# UNITED STATES PATENT AND TRADEMARK OFFICE

10/591,312

<b>Office Action Summary</b>	<b>Application No.</b> 10/591,312	<b>Applicant(s)</b> NEWTON, DOUGLAS PAUL	
	<b>Examiner</b> MICHAEL C. STOUT	<b>Art Unit</b> 4123

## **DETAILED ACTION**

FIG. 2

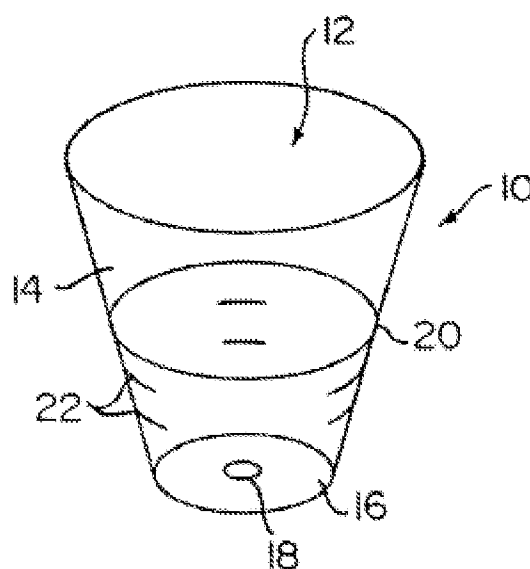
Regarding **claim 1**, Currie discloses a flow measurement device comprising comprising a hollow body [body of the cup 10 defined by the sidewall 14] having an inlet [open end 12] for receiving fluid and an outlet [port 18], wherein the inlet and outlet are spaced apart from each other [see Figure 2], the cross-sectional area of the body being greater than the cross-sectional area of the outlet (the cross-sectional area of the outlet shown in Figure 2 is smaller than the body) and wherein in use the device is oriented such that the inlet is above the outlet and the measured peak flow is proportional to the maximum height of fluid within the body (urine enters the opening of the cup and drains through the port, the level of the urine in the cup will continue to increase until the rate of the stream entering the cup is equal to or less than the rate of the urine exiting the cup, Column 4, Lines 17-40).

Regarding **claim 2**, Currie further discloses the device wherein the outlet is circular in cross-section (port 18, Figure 2).

Regarding **claim 12**, Currie further discloses the device wherein the hollow body is cylindrical in shape (wall of the hollow body defines a surface that is cylindrical in shape Figure 2).

Regarding **claim 14**, Currie further discloses a device wherein the hollow body comprises at least two portions each having different cross sectional areas (the cross sectional area of the hollow body decreases from one end to the other and results in

two portions of the hollow body having different cross sectional areas, see Figure 2 and Column 5 Lines 43-59) .

Regarding **claims 15 and 16**, Currie teaches a device wherein the cross-sectional area increases (Figure 2) wherein the scale means for determining the peak height of the fluid comprises the increase in cross-sectional area of said hollow body (the scale means comprises the increase in cross-section area which is used to determine the volume of the cup at that level, see Column 4, Lines 49-65)
